Technical Advisory Committee

Comments for Draft IDNR WWDS

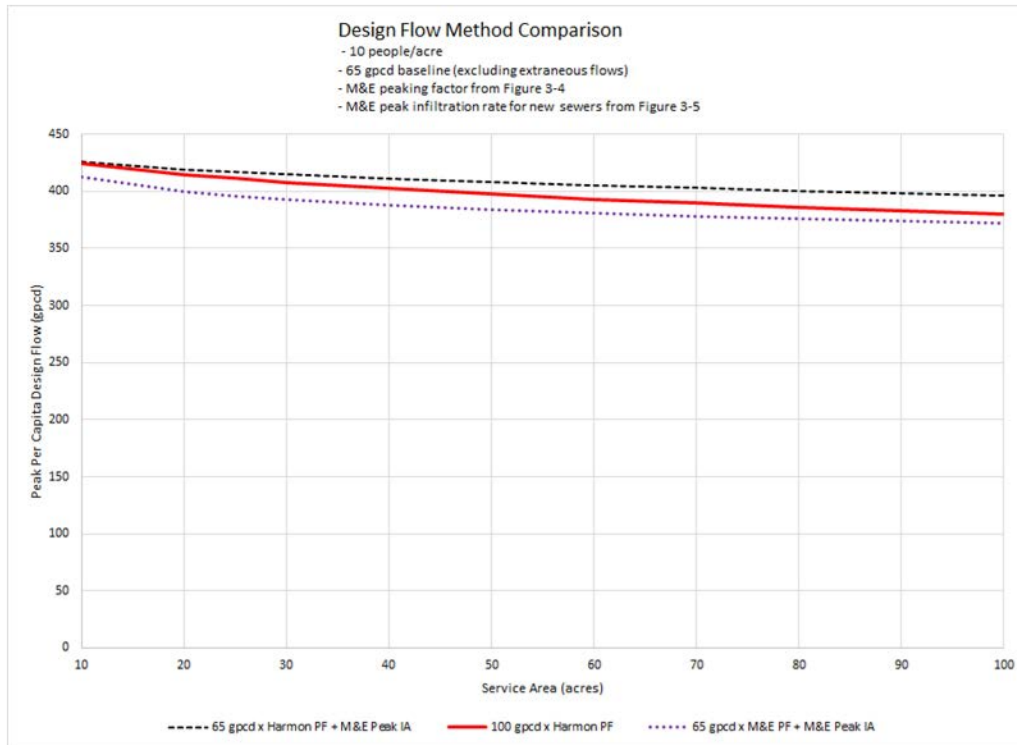
- 2. 12.1.3.1 Delete, this is a legal definition and not a WWDS definition.

DNR Response: We have consulted with DNR's Legal Services Bureau and they have advised that there is no issue from a legal perspective with the explanation of terms.

Figure 1: 8" Sewer @ 0.4%

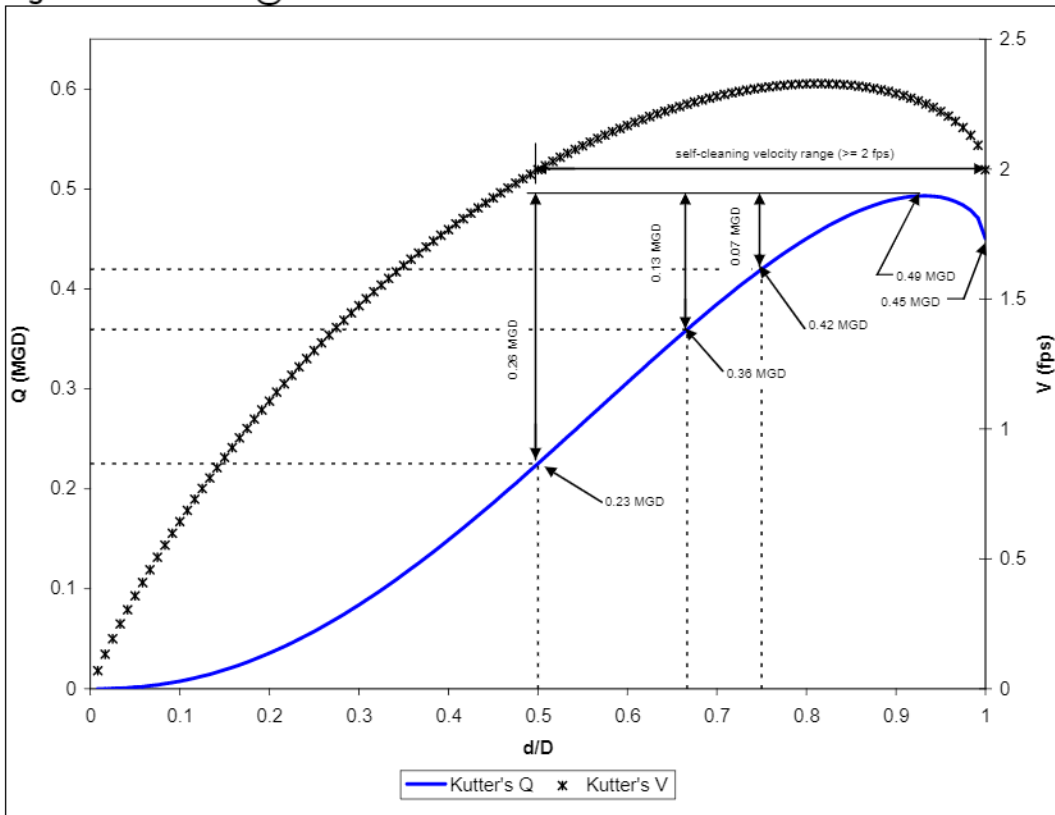
8. 12.3.4. Why are we limiting to less than 94-100% of pipe carrying capacity? If a safety factor is desired, indicate to provide a safety factor and justify desired safety factor. Significant overdesign of systems requires flushing to clear out pipe at low flow conditions. Would IDNR be held liable for such conditions if design requirements result in overdesign causing operational issues?

DNR Response: The DNR has previously explored the rationale behind this standard. See the attached “Design Maximum Depth of Flow” paper.
